DEVELOPMENT APPLICATION ASSESSMENT REPORT

Application Number:	DA2021/1762	
Responsible Officer: Phil Lane		
Land to be developed (Address):	Lot 8 DP 219278, 12 Boyer Road BEACON HILL NSW 2100	
Proposed Development:	Construction of a dwelling house	
Zoning:	Warringah LEP2011 - Land zoned R2 Low Density Residential	
Development Permissible:	Yes	
Existing Use Rights:	No	
Consent Authority:	Northern Beaches Council	
Land and Environment Court Action:	I: No	
Owner:	Steven Bennett Karen Louise Bennett	
Applicant:	Clarendon Homes Pty Ltd	
Application Lodged:	01/10/2021	
lute anote d. Deviele une enti	NI -

western elevation

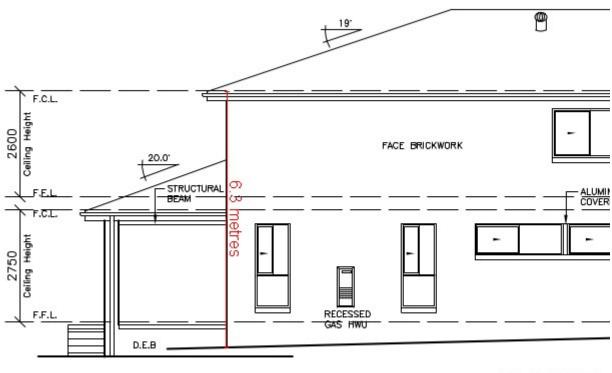
<u>Comment:</u> Issue was raised about privacy to the bedroom window on the eastern elevation of 10 Boyer Road. A review of the amended plans demonstrates there are a number of windows on the western elevation of the proposed dwelling as follows:-

Living Room (central) the proposed window for the living room has a high sill level of 1.7m (in height) above the finished floor level and therefore considered to ensure reasonable amenity for both parties.

Family Room (northern) the two (2) proposed windows will be conditioned to be fitted with obscured/frosted glazing and/or fitted with a high sill of 1.7m (in height) above the finished floor level. It is noted that room also has a large northern facing window which will ensure sufficient light and ventilation for this room.

Bedroom 4 is central located with a standard sill height of 1m in height above the finished floor level. It is considered conditioning of this window with external louvres to a minimum height of 1.5m above the finished floor level (first floor) and/or the installation of a high sill window with a minimum sill height of 1.5m above the finished floor level (first floor) would be a reasonable outcome for both parties noting that the room is a bedroom and considered to a low usage room

- Building height is to be amended to a maximum of 8.5m in height (RL126.300).
- Family Room (western elevation) the two (2) proposed windows will be conditioned to be fitted with obscured/frosted glazing and/or fitted with a high sill windows with a minimum sill height of 1.7m above the finished floor level.
- Bedroom 4 is to be fitted with external louvres (with a maximum spacing of 20mm), in materials that complement the design of the approved development to a minimum height of 1.5m above the finished floor level (first floor) and/or the installation of a high sill window with a minimum sill height of 1.5m above the finished floor level (first floor).

Figure 1. East Elevation

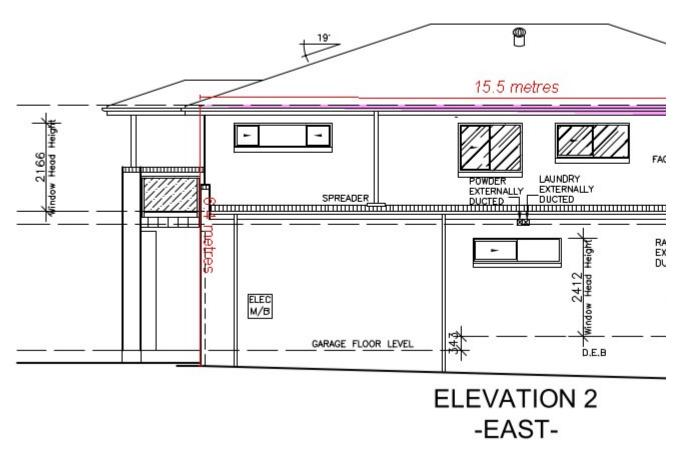
The proposal is sited outside of the building envelope along the east elevation as depicted in Figure 1. The east elevation encroaches outside of the building envelope for a maximum of 0.4m at the northern end for the horizontal length of 15.5m, resulting in a variation of 10%.

In this instance, the encroachment of the building envelope control is considered to be numerically noncompliant, however the proposal demonstrates compliance with the objectives of the control as outlined below. Therefore, the variation to the building envelope control is considered to be supportable.

ELEVATION 4 -WEST-

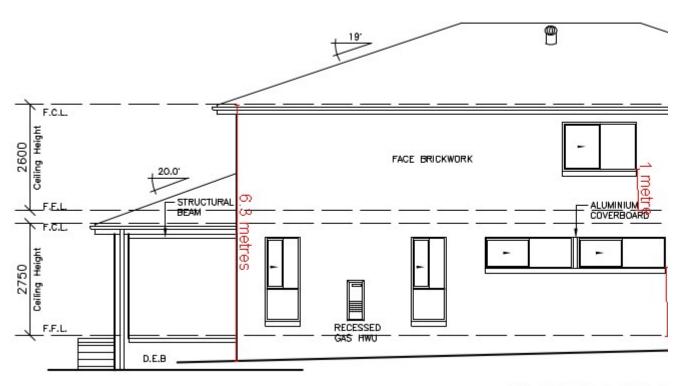
Living Room (central) the proposed window for the living room has a high sill level of 1.7m (in height) above the finished floor level and therefore considered to ensure reasonable amenity for both parties.

Family Room (northern) the two (2) proposed windows will be conditioned to be fitted with obscured/frosted glazing and/or fitted with a high sill of 1.7m (in height) above the finished floor level. It is noted that room also has a large northern facing window which will ensure sufficient light and ventilation for this room.

Bedroom 4 is central located with a standard sill height of 1m in height above the finished floor level. It is considered conditioning of this window with external louvres to a minimum height of 1.5m above the finished floor level (first floor) and/or the installation of a high sill window with a minimum sill height of 1.5m above the finished floor level (first floor) would be a reasonable outcome for both parties noting that the room is a bedroom and considered to a low usage room compared to the living room or kitchen (high usage rooms/areas).
